Contents List

Hunter GA. Mk.11 Aircraft-Fuel System - De-fuelling Cock, Locking Improved

Hunter G.A. Mk. II Aircraft - Fuel System, Single Filter,
Part No. D.10721 (Ref. No. 27VC/89) introduced in place of
Two Filters (Ref. No 26FX/8582) to Protect Pressure
Reducing Valves

Hunter G.A.Mk.11 and P.R.Mk.11 Aircraft-Fuel System-Air Supply-To introduce Non-Return Valve, Part No. 708AA25/B (Ref.No.27FC/145562) in lieu and by conversion of NRV. Part No. 708AA17/B/1 (Ref.No. 27F/7869). Part A: In Air Pressure Line to Engine. Part B: In Air Pressure Lines to Wing Tanks.

DRG. NO. AP4347L/H1/62

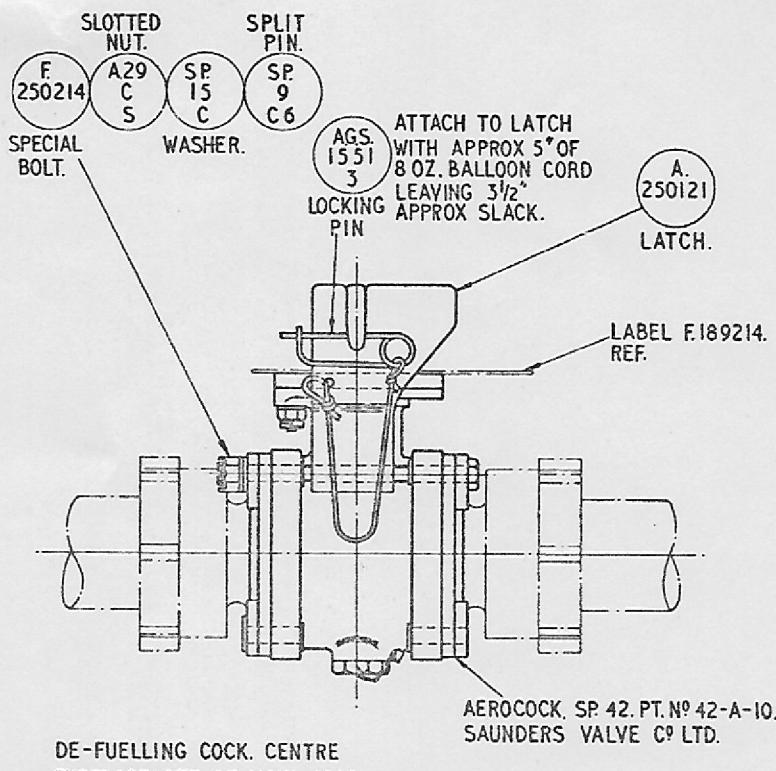
To prevent the possibility of engine flame-out due to the de-fuelling cock not being fully closed, a locking latch is introduced to ensure that the cock is fully closed before final locking.

- (1) Remove the engine starter access door.
- (2) Locate the de-fuelling aercock, Type SP.42, Saunders Valve Co. Ltd., Part No. 42.A.10, situated aft of the main spar on the port side, and fit latch, Part No. A.250121, as shown and in accordance with the instructions on the drawing.
- (3) Replace the engine starter access door.

ASSEMBLE LATCH BY SCREWING IN SPECIAL BOLT, ALLOWING LATCH TO ASSUME ANY MID-POSITION CLEAR OF EACH END OF THREADED INSERTS. ASSEMBLE SLOTTED NUT AND WASHER, ENSURING THAT BOLT IS FREE TO ROTATE. ADJUST LATCH BY TURNING BOLT SO THAT SLOT ENGAGES THE LEVER, ALLOWING NO MOVEMENT OF LEVER WITH THE COCK IN THE FULLY CLOSED POSITION.

NOTE: LOCKING OF BOLT TO LATCH IS UNNECESSARY AS NYLON THREAD IS PROOF AGAINST VIBRATION.

DRG. NO. AP4347L/H2/63

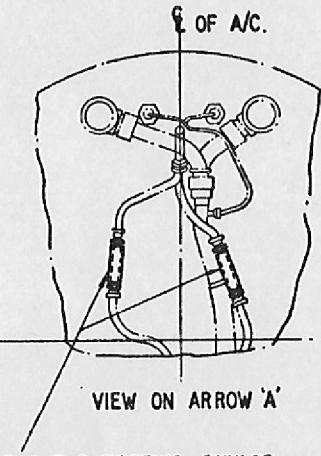
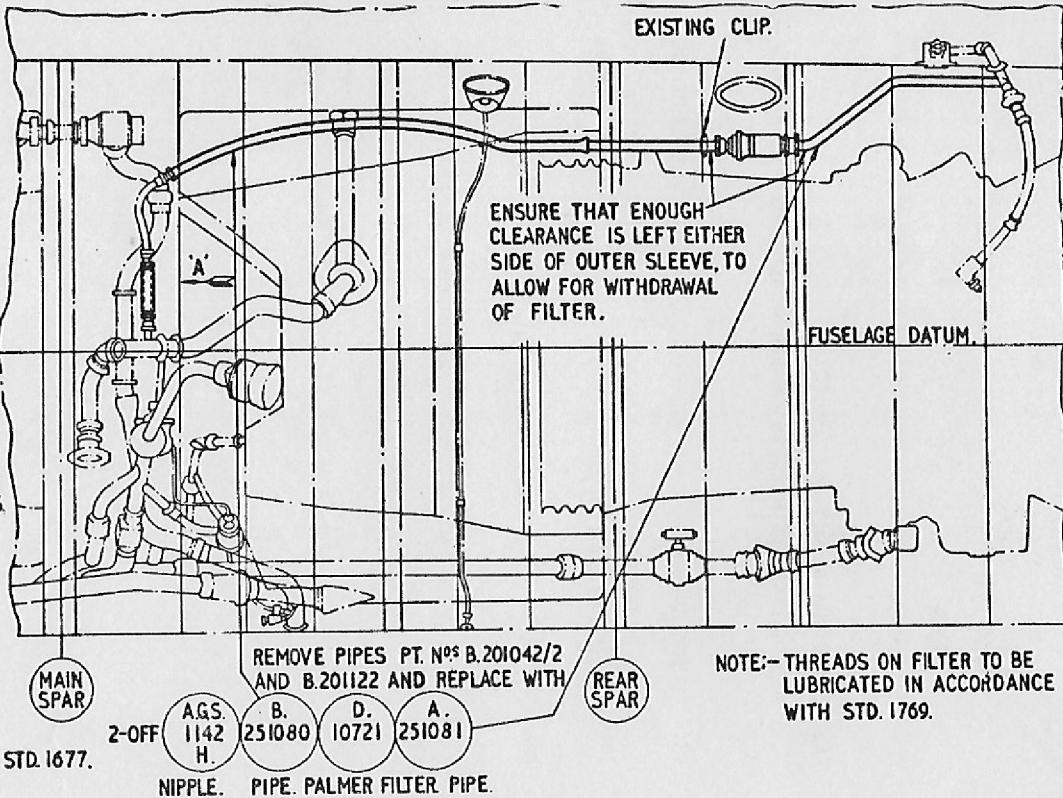
A single air filter, Part No. D.10721 (Ref. No. 27VC/89) has been introduced into the fuel system in place of the two existing air filters, to increase protection against dirt particles damaging the hydraulic pressure reducing valves.

- (1) Remove the E.C.U. (A.P. 4347, Vol. 1, Sect. 4, Chap. 1 refers).
- (2) Refer to the drawing and disconnect and remove the Dunlop air filters, Part No. B.218125, port and starboard, and replace with link pipes, Part No. A.251082, using new connecting nipples, Part No. AGS.1170.F.
- (3) Disconnect and remove air pipe, Part No. B.201122 between frames 28 and 33, and branch pipe, Part No. B.201042/2, between frames 33 and 36.
- (4) Fit new air pipe, Part No. B.251080 between frames 28 and 33 and new branch pipe, Part No. A.251081 between frames 34 and 36.
- (5) Fit air filter, Palmer Aero Products Ltd., Part No. D.10721 (Ref. No. 27VC/89) between new pipes, Part Nos. B.251080 and A.251081, using nipples Part No. AGS.1142.H.

REMOVE 2 EXISTING DUNLOP
FILTERS PART NO. B.218125 & NIPPLES.
AND REPLACE WITH:-

A. 251082 A.G.S. 1170
LINK NIPPLE.
PIPE. 4-OFF.
2-OFF.

PIPE COUPLINGS TO BE WIRE LOCKED TO STD.1677.
